Change Nr, Title 20007358, ADD FUSE MARKINGS ON FUSE HOLDERS
Date of issue 22.12.2020

To add fuse markings on fuse holder.

Figure 1: Fuse-holder appearance before change

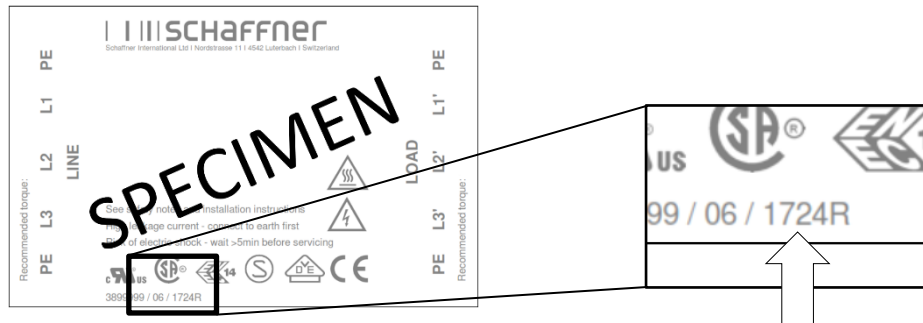
To be compliant with the updated standards IEC60320-1:2015 / CSA C22.2 No. 42-10 §7.1.4.
